DUANE ARNO D ENERGY CENTER

AMENDMENT TO FACILITY OPERATING LICENSE

Amendment No. 183 License No. DPR-49

ATTACHMENT TO LICENSE AMENDMENT NO. 183

Thermal Power vs Core Flow Limits for Thermal Hydraulic Stability Surveillancy Figure 3.3-1

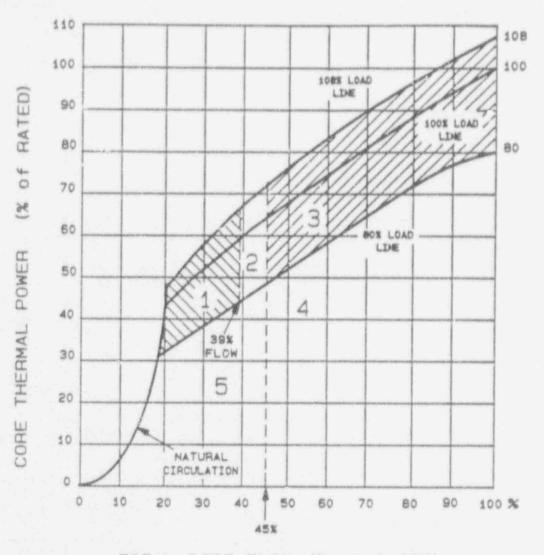
With two recirculation pumps in operation in Regions 1 or 2 of Figure 3.3-1, operation is permitted provided that:

d. Operation in Region 1 of Figure 3.3-1 is not permitted. If inadvertent entry into this region occurs, immediately initiate corrective action by inserting control rods in an orderly manner to exit the region.

- e. Operation in Regions 2 or 3 of Figure 3.3-1 is permitted provided that:
 - (i) APRM and LPRM* neutron flux noise levels are s three times (3x) their established baseline values as determined by Surveillance Requirement 4.3.F.4.c.

- b. Prior to SLO operation in Regions 2 or 3 of Figure 3.3-1, establish baseline APRM and LPRM* neutron flux noise levels, provided that baseline values have not been previously established since the last core refueling. Baseline values shall be established during SLO and in the Regions below the 80% load line (Regions 4 or 5).
 - While in Regions 2 or 3 of Figure 3.3-1, determine APRM and LPRM* neutron flux noise levels at the following intervals:

APRM and/or LPRM oscillations in excess of those specified in section 3.3.F could be an indication that a condition of thermal hydraulic instability exists and that appropriate remedial action should be taken. Instability can occur in two loop or single loop operation. Therefore, instability monitoring is required in certain regions of Figure 3.3-1.

Above 45% of rated core flow in SLO there is the potential to set up high flow-induced noise in the core. Thus, surveillance of core plate AP noise is required in this region of Figure 3.3-1 to alert the operators to take appropriate remedial action if such a condition exists.

Region	1:	Two Loop Surv. Region, SLO Prohibited Region
Region	2:	- requires APRM/LPRM noise monitoring Two Loop & SLO Surv. Region
		- requires M/LPRM noise monitoring
Region	3:	SLO Surv. 1 Jn
		- requires APRM/LPRM & Core Plate D/P noise monitoring
Region	4:	Extended SLO Surv. Region
		- requires Core Plate D/P noise monitoring
Region	51	Unrestricted Two Loop & SLO Region
